Erection of two storey house and garage

Garden Ground to East of
4 Strips of Craigie Road,
Dundee

Proposed New House in Garden Ground at Strips of Craigie Road

The erection of a two storey house and garage is **RECOMMENDED FOR REFUSAL**. Report by Director of Planning and Transportation.

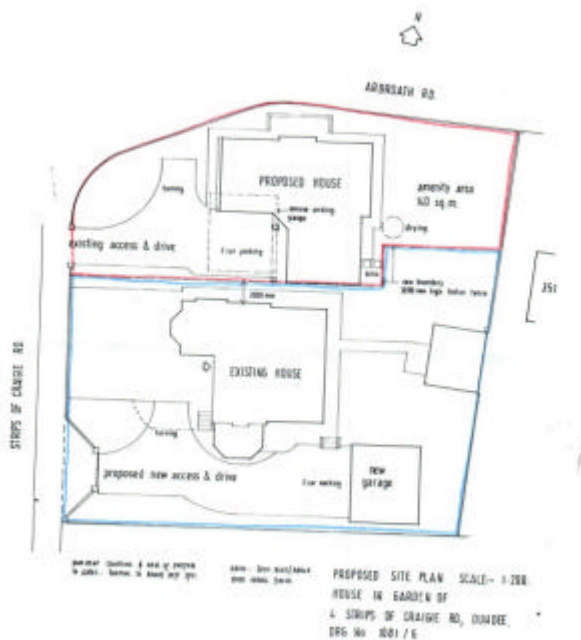
Planning permission is sought to erect a two storey house in garden ground to the east of the 4 Strips of Craigie Road and on the south side of Arbroath Road. The proposal includes the demolition of an existing double garage to the north of the original house and the proposed house will be built on this site at the north end of the garden, which gently slopes upwards towards Arbroath Road. There will be 2m between the proposed and existing houses.

During the application process the applicant submitted revised plans to indicate that the house will be reduced in height by approximately 0.7m in an attempt to minimise its scale and massing and overall visual impact at this location.

a The proposal is of high quality design and uses materials appropriate to its surroundings. In this case it is considered that the materials of the proposed house are satisfactory in terms of integrating with surrounding properties. The scale of the house is not considered appropriate at this prominent location on the corner of two busy roads. It will sit at a very prominent location, when viewed from both the Kingsway and Arbroath Road. The proposed house does not comfortably follow the building line of the houses along Arbroath Road or those along Strips of Craigie Road and will be very

prominent when travelling along Arbroath Road, in particular. The proposed house is only 2m from the original house to the south and it is questionable whether the amenity for occupants will be acceptable. It is concluded that the proposal does not comply with part a of Policy 15.

The proposed finishing materials are beige roughcast walls and concrete tiles for the roof. It is considered that the design of the proposed house is satisfactory, however the height is not considered acceptable as it will result in an overly-dominant development at this prominent location.

- 1 The proposal fails to comply with Policy 4 of the Dundee Local Plan Review 2005 due to the density, mass, height and position of the proposed house on the site at this prominent location. There are no material considerations in these circumstances that would justify approval of the application contrary to the provisions of the development plan.
- 2 The proposal fails to comply with parts A and D of Policy 15 of the Dundee Local Plan Review 2005 due to the scale, massing and density of the proposed development, which does not satisfactorily integrate with the surrounding environment. There are no material considerations in these circumstances to justify approval of the application contrary to the provisions of the development plan.
- 3 The introduction of a second vehicular access within close proximity to a major junction will intensify the level of traffic taking
